UNITED STATES PATENT AND TRADEMARK OFFICE

Office Action Summary	Application No. 10/821,737	Applicant(s) SCHWEINBENZ ET AL.	
	Examiner ZACHARY M. PAPE	Art Unit 2835

DETAILED ACTION

Fig 1

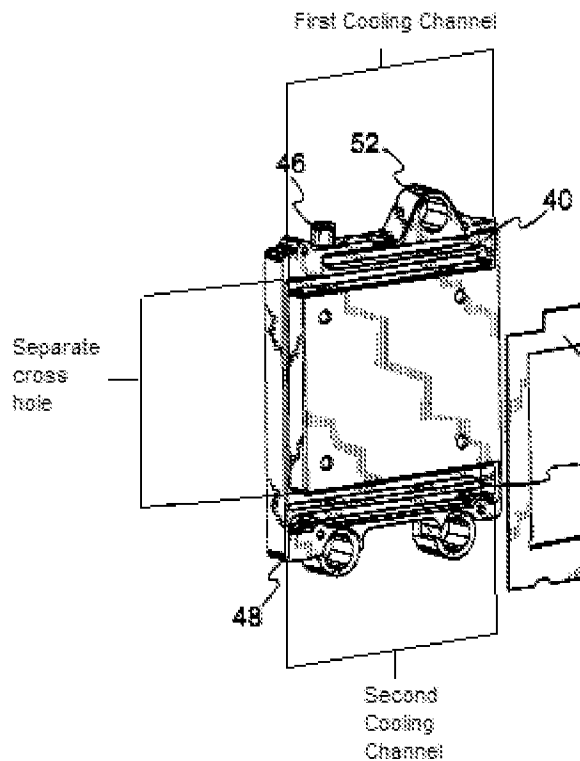
With respect to claim 9, Clamp et al. further teaches that the cooling device includes a plurality of one-piece cooling tubes integrally formed in the bottom section

(See Present Office Action Fig 1 below where the first cooling channel, and the second cooling channel, form a plurality of one-piece cooling ducts).

With respect to claim 10, Clamp et al. further illustrates that the one-piece cooling tubes are connected by at least one separate cross hole (Running along the left side of the bottom as illustrated in Fig 2 and present office action Fig 1 below).
